STAFF MEMORANDUM
Zoning Administration
May 19, 2023

File: PLN21-130

Concurrent Land Use Permit for a Building Approval, Grading Approval, and Variance for a New Single-Family Residence

Revised OWTS Plan

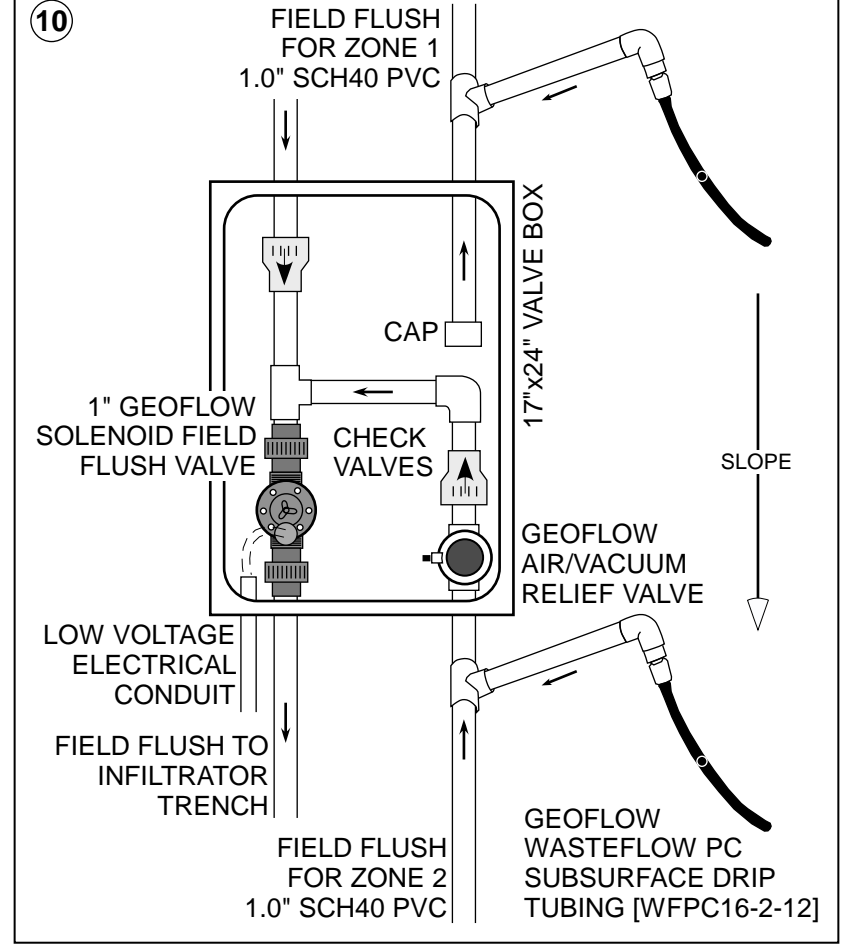
- 1) The distance from the septic leach field to adjacent wells should be determined to maintain proper separation - the location of existing wells were not specifically noted on the plans.

Please reconsider to add extra distant the septic system of 17025 McGill rd to the water well of XXXXX McGill rd. My family has full right to preserve the well from septic contamination. Please please do this right so we all live harmony up here. We live here 4.5 years. This 10 acres new development should design with public safety of immediate neighbor in mind. We are not opposed to the development but please add extra distant from the septic system to our water well. Thank you in advance and look forward to hearing from you.

DEH Staff reached out to both neighbors to confirm the locations of their wells. DEH requires that leech fields (and septic tanks) be located at least 100 linear feet from any water well or spring to ensure the water quality is not compromised pursuant Section B11-67(I)(6) of the County Ordinance. DEH Staff reviewed plans and conducted a site visit to determine if the proposed leech field for the project met this requirement. Additionally, the applicant has proposed a minor design modification that will add some additional distance from the closest of the two wells (refer to **Attachment D**). The revised plans do not account for all of the wells, so, for additional assurance, Staff has added Condition of Approval No. 13 requiring that applicant verify with DEH that the setback requirement is met prior to the applicant submitting for building permits (refer to **Attachment E**).

- a. 1250 square foot plus 1250 square foot dual drip dispersal fields (or for a single field total of 2500 square foot).
- b. 1500-gallon septic tank, an Advantex AX20 treatment device, and 2000-gallon
